# UNITED STATES PATENT AND TRADEMARK OFFICE

APPLICATION NO.	FILING DATE	FIRST NAMED INVENTOR	ATTORNEY DOCKET NO.	CONFIRMATION NO.
10/582,736	06/13/2006	Simon Udo	ESQ0650.001	5018

<b>Office Action Summary</b>	<b>Application No.</b> 10/582,736	<b>Applicant(s)</b> UDO ET AL.	
	<b>Examiner</b> JENINE M. PAGAN	<b>Art Unit</b> 3728

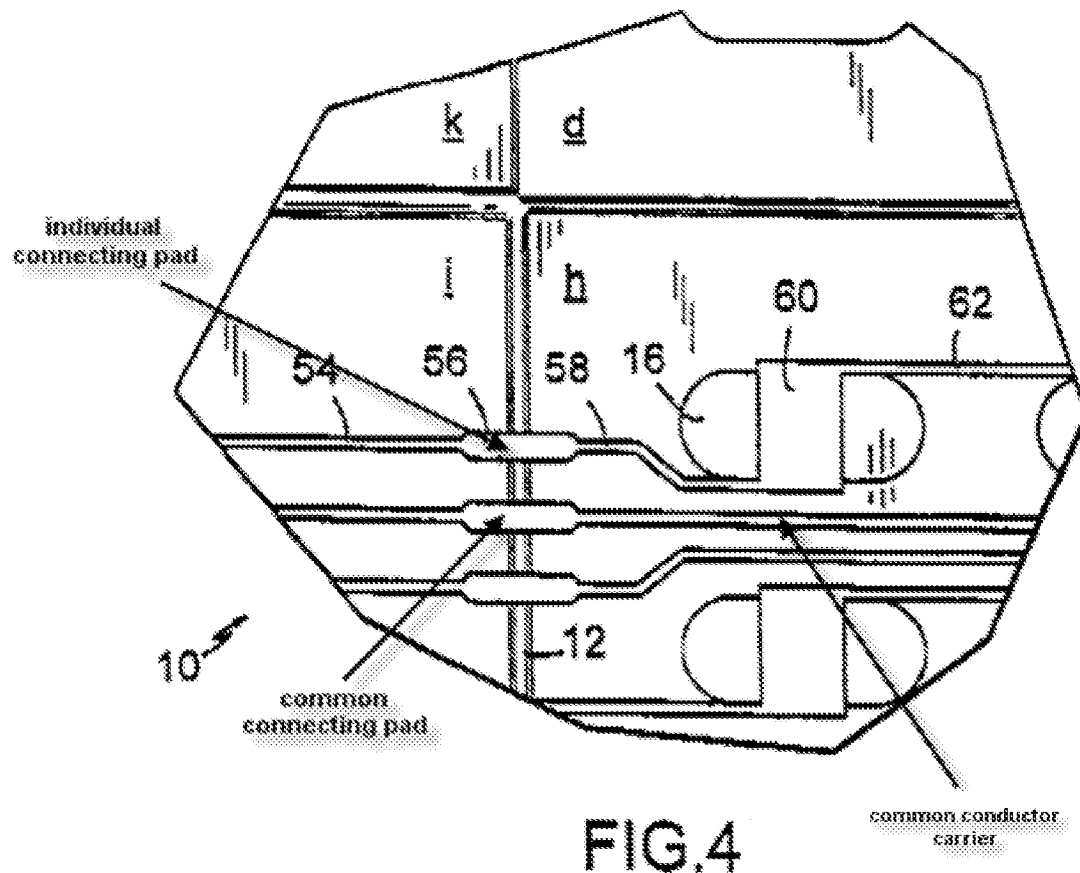
**Claim 1:** Ehrensvard discloses a blister package (Col 3:63-4:13 Fig. 4 and 5):  
an arrangement with a blister package 40 and a conductor carrier (58/60/62)/see figure above connected to it, wherein openings in the conductor carrier are

**Claim 2:** Ehrensvar discloses a blister package (Col 3:63-4:13 Fig. 4 and 5): each individual conductor (58/60/62), at its end opposite its associated individual connection pad 56, is connected with a common conductor 76 which is connected to a common connection pad (see figure above)

**Claim 3:** Ehrensvar discloses a blister package (Col 3:63-4:13 Fig. 4 and 5): the individual connecting pads 56 and the common connection pad (see figure above) are components of an interface, which upon insertion of the blister package arrangement 40 in a receiver device, effect a defined position

the conductor carrier (58/60/62)/(see figure above) includes the individual conductors (58/60/62) on the side facing away from the blister package 40, and

the conductor carrier (58/60/62)/(see figure above) is at least partially provided with an electrically insulating protective 90 on its side facing away from the blister package that covers at least the individual conductors and a common conductor (58/60/62)/(see figure above)

the conductor carrier (58/60/62)/(see figure above) includes the individual conductors (58/60/62) on its side facing toward the blister package 40, and that the side of the conductor carrier facing toward the blister package is provided with an electrically insulating layer 90 covering the individual conductors (58/60/62), and wherein the side of the electrically insulating layer 90 facing toward the blister package is connected with the sealing film 10 of the blister package

the conductor carrier (58/60/62)/(see figure above) projects over the blister package 40 at least on the side of the interface

the conductor carrier (58/60/62)/(see figure above) forms a first component (a) of the carrier that folds like a book, and a second component (j) forms at least one of an insertion opening 70 for each pocket of the blister package 40 and a common insertion opening for all pockets of the blister package, and may be folded about a fold line 12 with respect to the conductor carrier (58/60/62)/(see figure above) so that the blister package 40 is accepted between the conductor carrier (58/60/62)/(see figure above) and the second part, whereby each pocket of the blister package extends through an insertion opening 70 of the second component or all pockets of the blister package through the common insertion opening of the second component, and wherein the conductor carrier , the blister package, and the second component receiving the pockets of the blister package are connected with each other

the conductor carrier (58/60/62)/(see figure above) and the second component (j) project over the blister package 40 at least on the side of an interface of the conductor carrier with a receiver device 51

the conductor carrier (58/60/62)/(see figure above) and the second component (j) project over the blister package 40 on all sides

**Claim 21:** Ehrensvar discloses a blister package (Col 3:63-4:13 Fig. 4 and 5):  
a blister package 40 having a plurality of pockets each configured to receive a tablet 44 therein; and a conductor carrier (58/60/62)/(see figure above) connected to the blister package 40, the conductor carrier comprising:  
a cover 10 area positioned adjacent to each pocket in the blister package 40, each cover area defined by a stamped line 16 opening formed thereabout in the conductor carrier (58/60/62)/(see figure above);  
at least two bridge parts 17/19 interrupting each stamped line 16 opening to connect each cover area to a surrounding conductor carrier area, the at least two bridge parts 17/19 positioned such that at least one bridge part is broken when a tablet 44 is pressed out from the corresponding pocket; and  
an individual conductor (58/60/62) extending over the at least one bridge part, the individual conductor (58/60/62) configured to break along with the at least one bridge part 17/19 that is broken when a tablet 44 is pressed out from the corresponding pocket
